# Access Compliance Report

## Public Rights-of-Way

Intersection ID: 46500	Main Street: NEWBRIDGE_RD	Cross Street: ROCK_ISLAND_RD	Location: NW
ADA ID: A3175BF3ADA1	Ramp Type: PerpDiag	Initial Pass/Fail: Fail	Overall Compliance: No
		Severity Score: 22.5

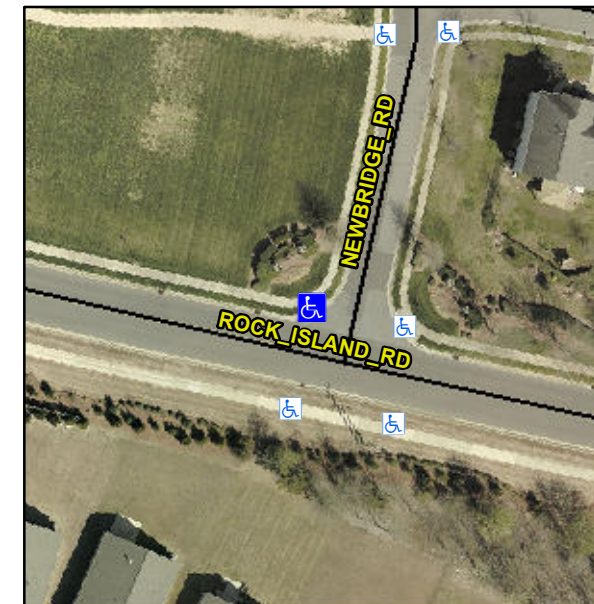
**R304.5.1, R304.2.2, R304.5.3**

Compliance	Description	Data	Compliance	Description	Data
N/A	Ramp Length (in)	50.0	No	Ramp Slope (%)	10.0
No	Ramp Width (in)	47.5	No	Ramp XSlope (%)	3.9
N/A	Flare Type LT	N/A	N/A	Flare Type RT	N/A
N/A	Flare Slope LT (%)	N/A	N/A	Flare Slope RT (%)	N/A
N/A	Flare Traversable LT?	N/A	N/A	Flare Traversable RT?	N/A
N/A	Landing Length (in)	N/A	N/A	DWS Provided?	N/A
N/A	Landing Width (in)	N/A	N/A	DWS Contrast?	N/A
N/A	Landing Slope (%)	N/A	N/A	DWS Length (in)	N/A
N/A	Landing X Slope (%)	N/A	N/A	DWS Full Width?	N/A
N/A	Landing Curb? (Y/N)	N/A	N/A	DWS Offset (in)	N/A
N/A	Shared Landing?	N/A			
N/A	Gutter Ponding?	N/A	N/A	Gutter Slope (%)	N/A
N/A	Gutter Lip Ht (in)	N/A	N/A	Gutter X Slope (%)	N/A
N/A	Painted X Walk1?	No	N/A	Painted X Walk2?	No
	X Walk 1 Direction	To SW		X Walk 2 Direction	To SE
N/A	X Walk 1 Width (in)	N/A	N/A	X Walk 2 Width (in)	N/A
	X Walk 1 Slope (%)	0.2		X Walk 2 Slope (%)	0.8
	X Walk 1 X Slope (%)	1.0		X Walk 2 X Slope (%)	3.6

**Remove & Replace Curb Ramp With Two New Directional Ramps or Equivalent.**
